SERVICE BULLETIN NO. 171

Differential pressure transmitter

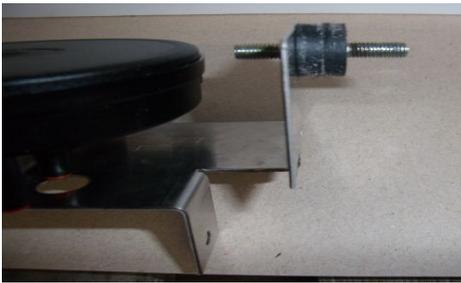
To stabilise the signal from the differential pressure transmitter, HOUNÖ has decided to add a "vibration absorber" and two "pulsing nozzles" when the transmitter is fitted.

The two components have been introduced on ovens with serial No 09 10 xxxxx onwards.

We recommend that you fit these two components on ovens where ClimaOptima appears to be unstable.
